Pre-Application Report

Case Number / AMANDA No.	PRE-AP20-23 / 20-103495-PA
Conference Date	March 12, 2020
Applicant	Ben Haney City of Salem, Public Works Department 555 Liberty Street SE, Room 325 Salem, OR 97301
Contact	Lael Alderman Murraysmith 888 SW 5 th Avenue, Suite 1170 Portland, OR 97204
Case Manager	Aaron Panko

Project Description & Property Information	
Project Description	A pre-application conference to discuss development of a new 3,000 square foot water treatment facility and three 900 square foot ASR wellhead buildings, for property approximately 28.7 acres in size.
Property Address	4635 Sunnyside Road SE
Assessor's Map and Tax Lot Number	083W10DB / 00300, 00400, 00500, 00600, 00700, 00800, 00900, 02200, 02300, and 03500
Existing Use	Woodmansee Park
Neighborhood Association	Faye Wright Neighborhood Association (Faye Wright)
Adjacent Neighborhood Association	NA
Comprehensive Plan Map Designation	Single Family Residential
Zoning	PA (Public Amusement) and RS (Single Family Residential)
Overlay Zone	NA
Urban Service Area	The subject property is located within the Urban Service Area.
Urban Renewal Area	NA
Past Land Use Actions	NA

WOODMANSEE PARK
CONCEPTUAL WATER
TREATMENT
FACILITY SITE LAYOUT

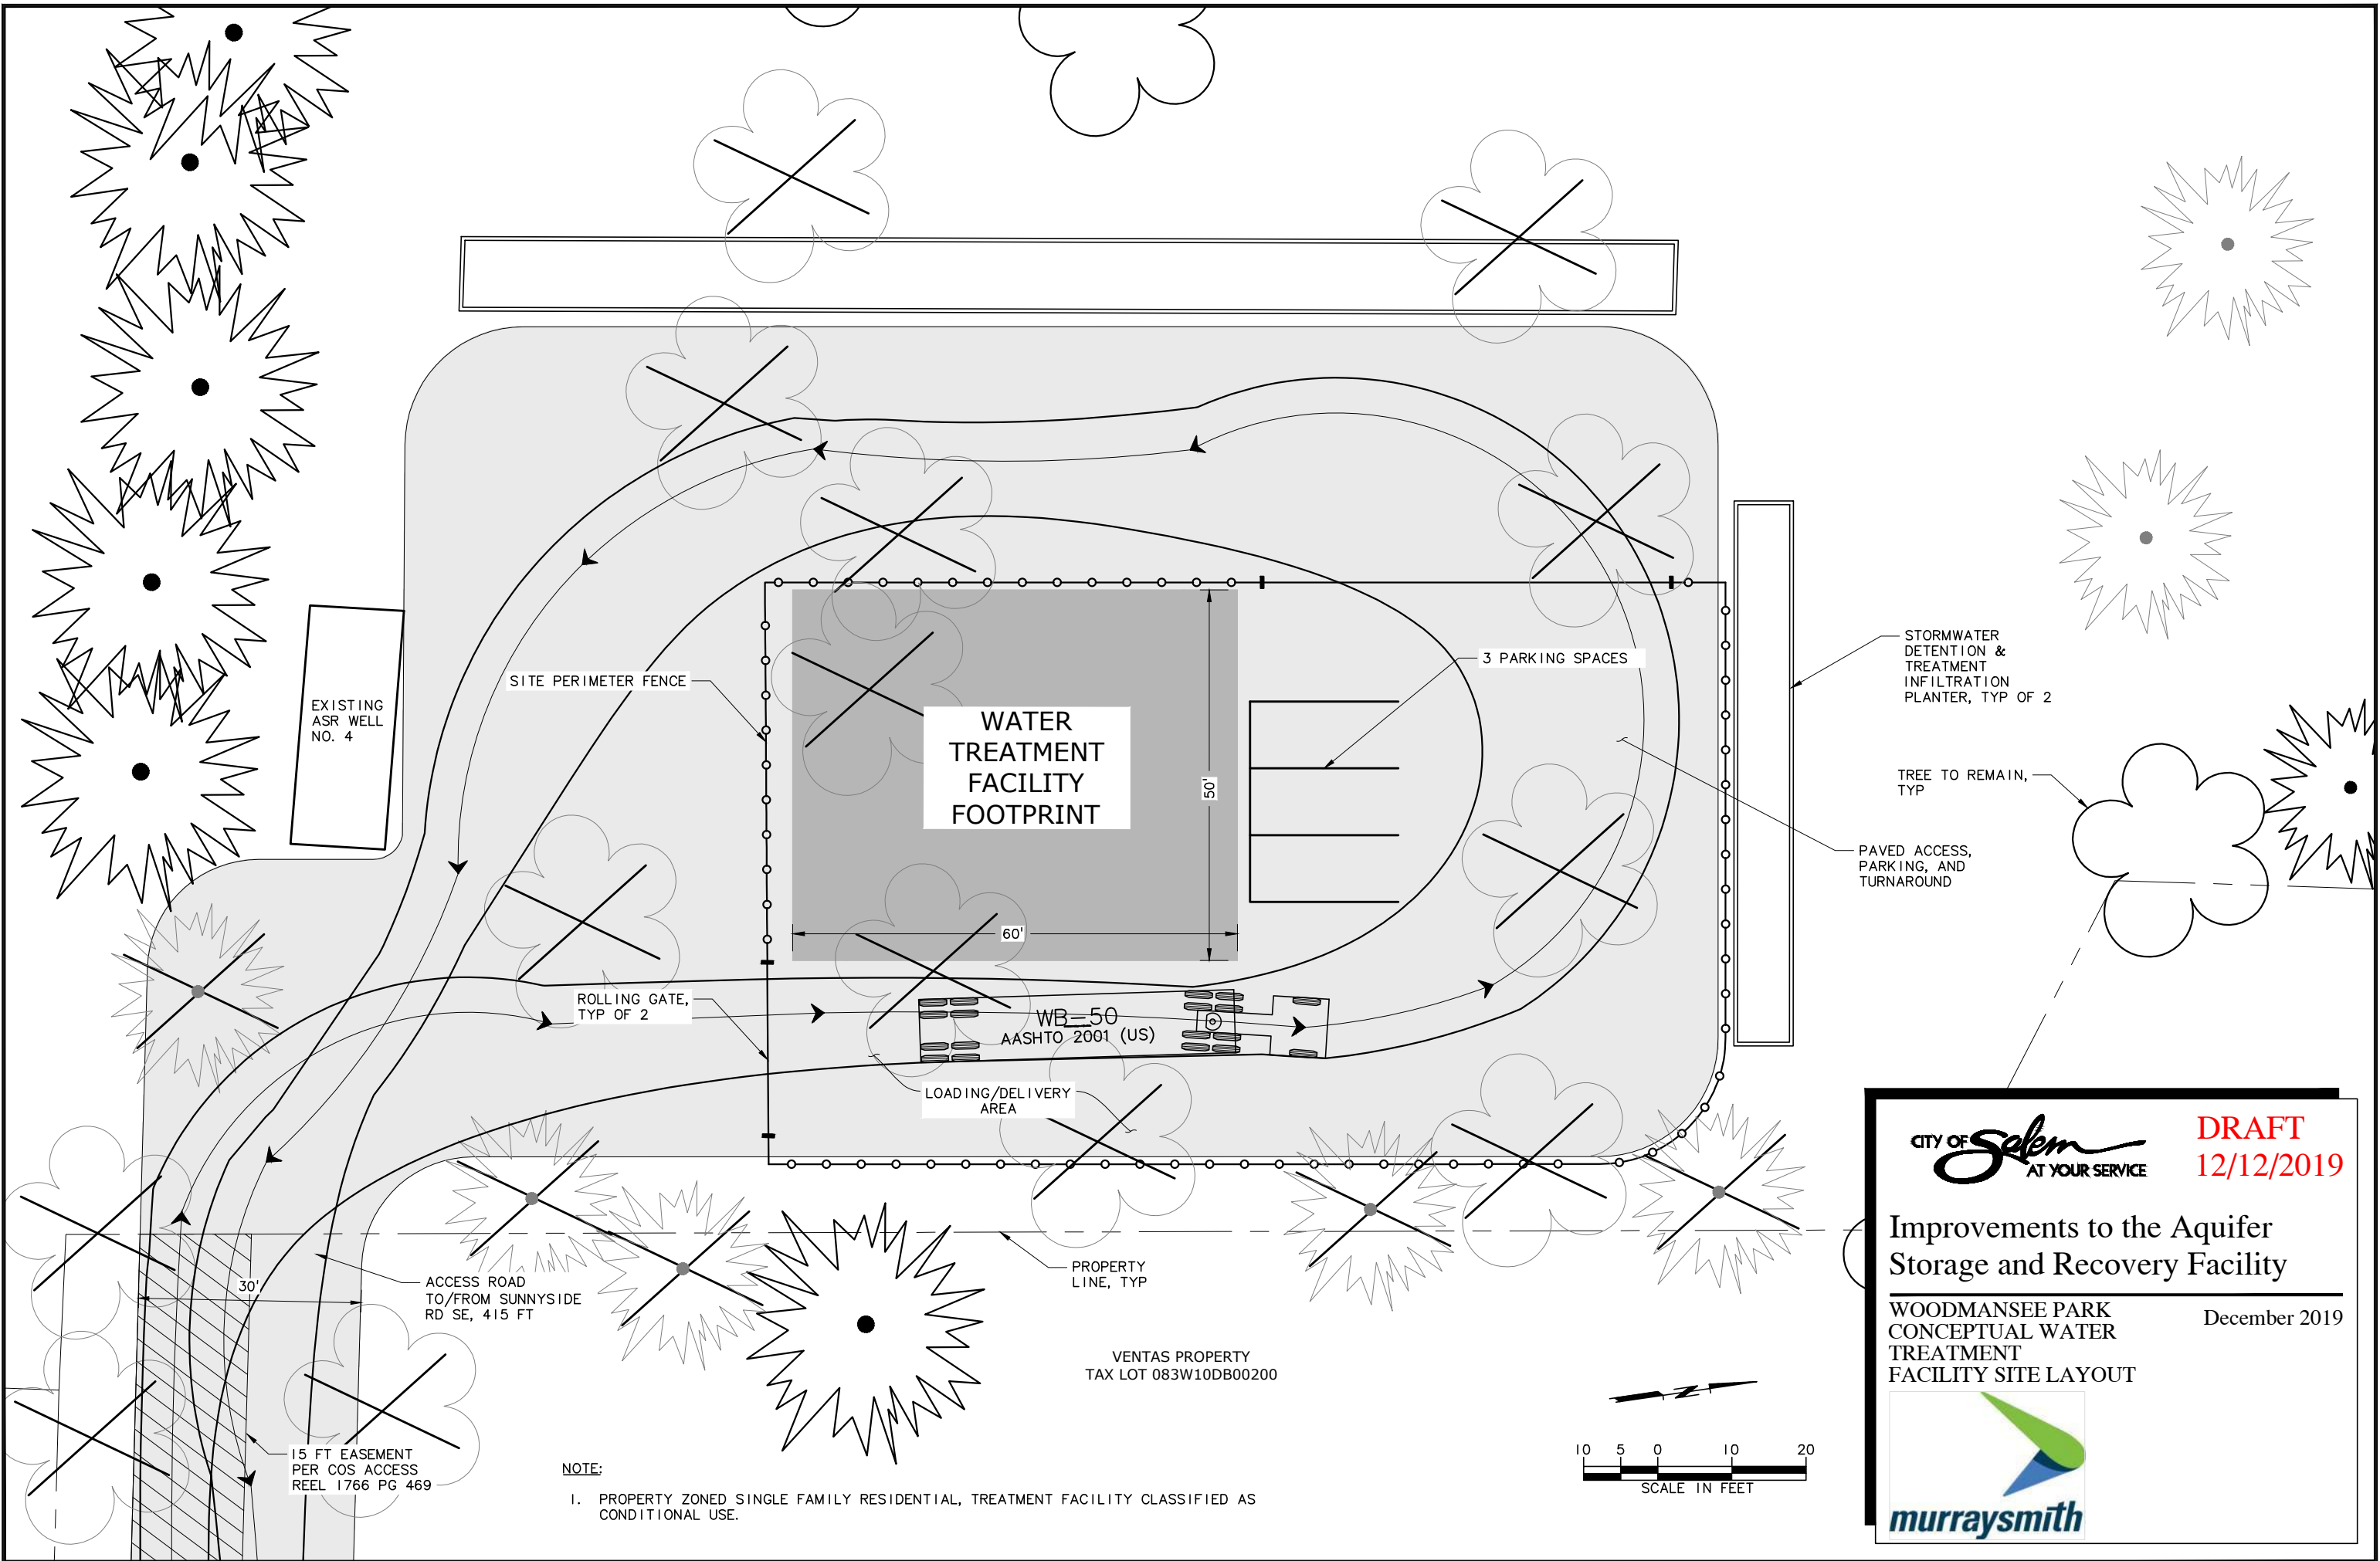
Staff Response: A minimum 5-foot-wide separation is required between the proposed building and vehicle use area. No separation was provided on the proposed site plan, because of the infrequent use of the facility and the desire to reduce the impervious surface footprint, the applicant may request an adjustment to reduce or eliminate the vehicle use area separation requirement adjacent to a building.

Staff Response: Pedestrian access is required between the proposed building entrance to the water treatment facility and Sunnyside Road SE. A Class 2 Adjustment is required to eliminate the pedestrian access requirement.

Staff Response: The proposed site plan shall demonstrate where existing/proposed pedestrian connections are provided between all existing/proposed buildings on the development site. The pathways shall comply with the design and material development standards in SRC 800.065(b).
